Flying Minute: Submission to the Review of the Main Roads Pedestrian Crossing Facilities Guidelines

By Max Bushell, Policy Officer Road Safety and Infrastructure

- Draft Pedestrian Crossing Facilities Guidelines with WALGA comments and revisions
- WALGA submission to Main Roads WA on the Pedestrian Crossing Facilities Guidelines

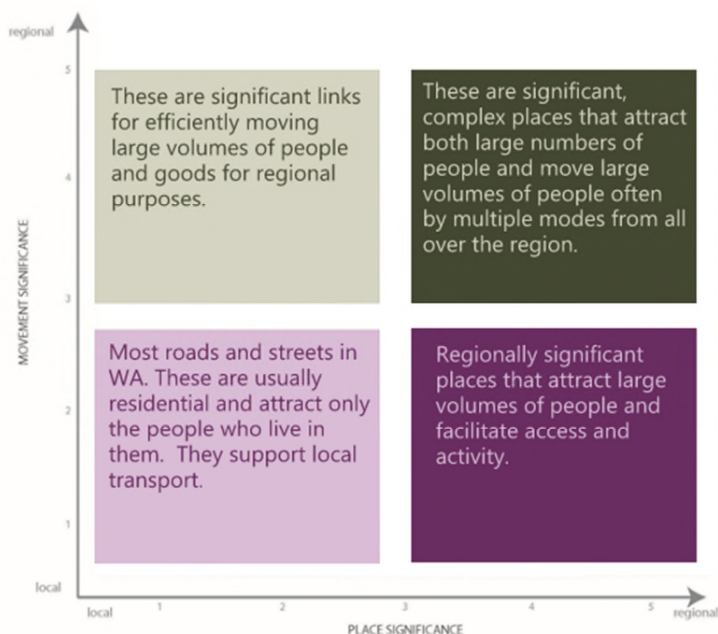
Commented [MB15]: What if the presence of high speeds and high volumes means there aren't any pedestrians, but the Local Government wishes to create a pedestrian-friendly environment, in line with the Strategic Plan or Transport Plan? Is there a provision whereby a Local Government can look forward, rather than having to demonstrate volumes of pedestrians that will never occur, due to unfavourable conditions for walking in the current day? Can the inclusion of areas in a Strategic Plan or Transport Plan be the basis for reducing speed/traffic volumes to create the conditions to support a pleasant and safe walking environment? Including sound planning as an option here would help Local Governments to use their understanding of the local context to implement a connected pedestrian network.

Pedestrian Delay LoS Estimate – 1-Way Carriageway

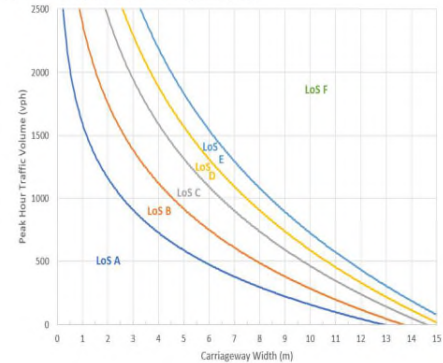
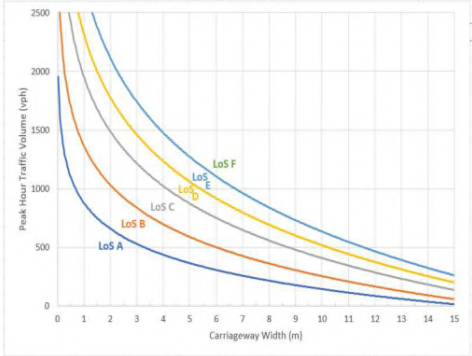
Commented [MB26]: Using this method would not account for localised knowledge of the area and an understanding of community wishes and desires. Local Governments may wish to use this as a guide, but would want to supplement with their knowledge of the context in making the final determination.

5.7.3 Traffic Delay based on calculation

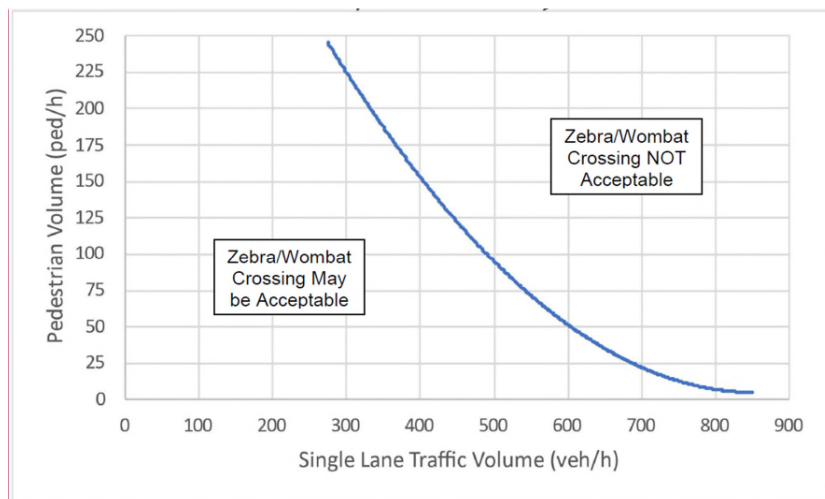
Commented [MB31]: As I've commented before, this type of analysis will often be used as a hard-and-fast rule. In some cases, accommodating pedestrians safely by giving them priority amidst high volumes of traffic is important. One case is outside of schools. Another would be near key community destinations likely to attract children or near aged care facilities. I think it's also important to acknowledge here the issue of planning of walking/cycling to school before building the school/associated road infrastructure. Please add something about children's crossings, acknowledging that schools may be built near major roads and children's crossings may not necessarily be adjacent or even within 500m of a school site.

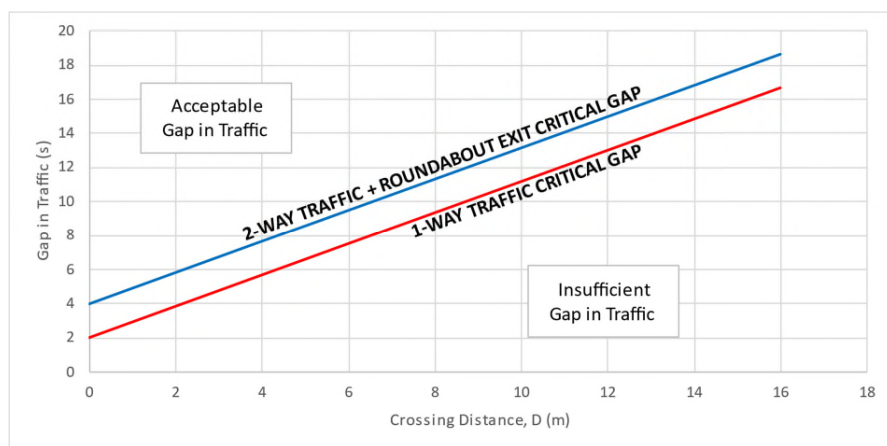
Commented [MB34]: This logic doesn't make sense to me and seems like a self-fulfilling prophecy. You're basically saying, "If there are no sensitive pedestrians, then we just won't cater for them." To create an environment friendly to active transport/pedestrians, ensuring that all pedestrians, particularly children and the elderly, are catered for should be paramount.

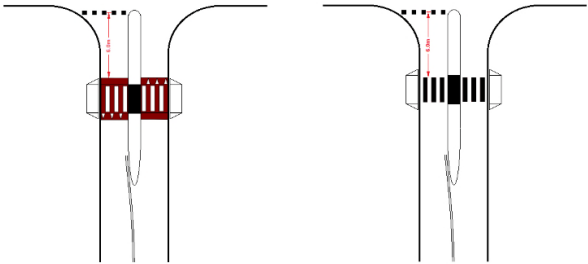
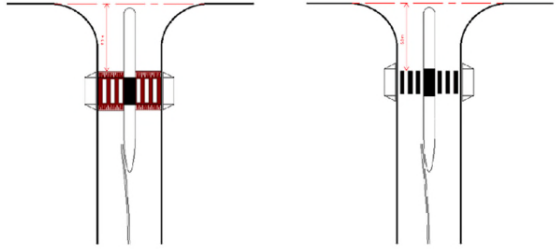
Commented [MB77]: Again, vehicular delay should not be considered as having higher value than pedestrian delay. Precisely in places where vehicular delay is likely to be high is where pedestrians need supportive infrastructure to cross. Please remove this consideration.

Commented [MB78]: This basically means that crossings will not be provided on these roads, as signalised mid-block crossings are very difficult to implement and grade-separated crossings are too expensive in most cases. As such, this means that pedestrians will be faced with an insurmountable barrier at high volume roads and will likely cross anyway, creating a dangerous situation. Please reconsider this warrant.

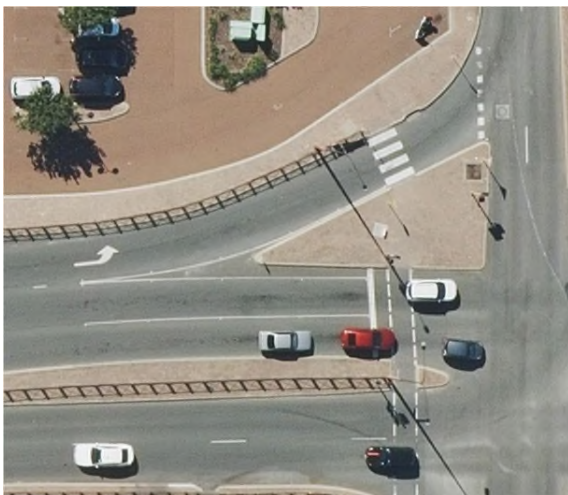
Commented [MB85]: This is also problematic. Roundabouts on 60 km/h roads also require safe pedestrian crossing ability.

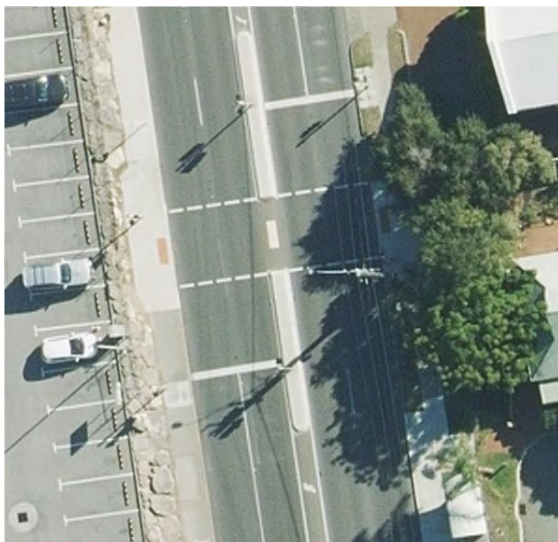
Commented [MB91]: This is clearly written from the perspective of traffic engineering for vehicles. Continuous pedestrian streams indicate that it is a vibrant area and all efforts should be made to better accommodate pedestrians. As such, vehicle delay should not be considered, e.g., most of the CBD.

Commented [MB92]: This is not a good solution for providing a safe, comfortable, and connected network for pedestrians. Accommodating pedestrians on desire lines is much better than making pedestrians go often long distances out of their way to cross.

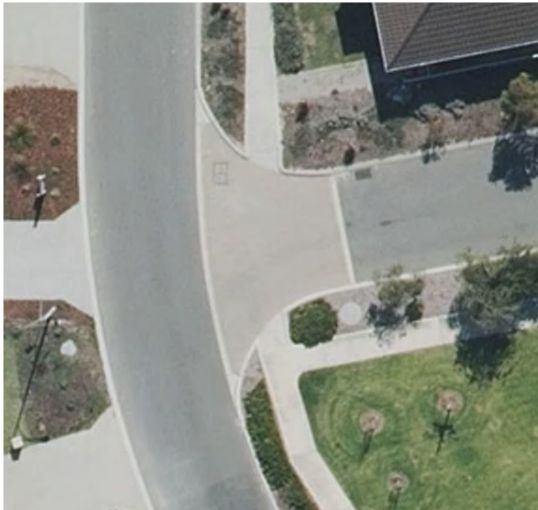
Commented [MB107]: This may lead infrastructure managers to abandon the provision of any pedestrian crossing, as either grade-separated crossings and/or pedestrian signals may be very difficult to implement due to cost. This is not an acceptable outcome.

Commented [MB108]: Please add speed limit reduction as an applicable treatment to support pedestrian crossings. This is an inexpensive and effective treatment in combination with a pedestrian priority crossing to support the development of safe, comfortable, and connected pedestrian networks.

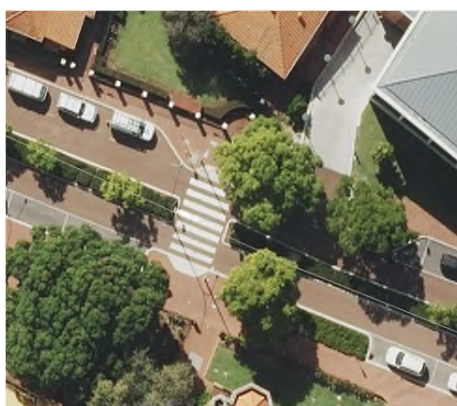
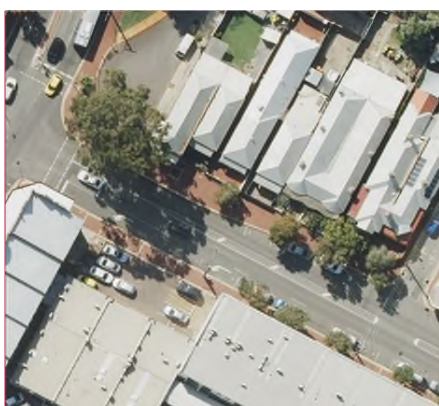
Commented [MB110]: This is a very wide road. I would argue a tighter crossing distance would be more appropriate, say, 7m.

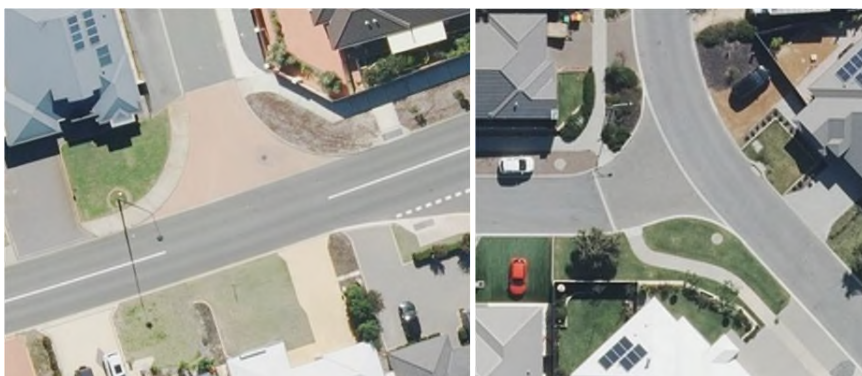
Commented [MB128]: If the road is low volume and the largest vehicle (often a rubbish truck) only makes a turning movement infrequently, I think the "lane-correct" assumption here should be relaxed.
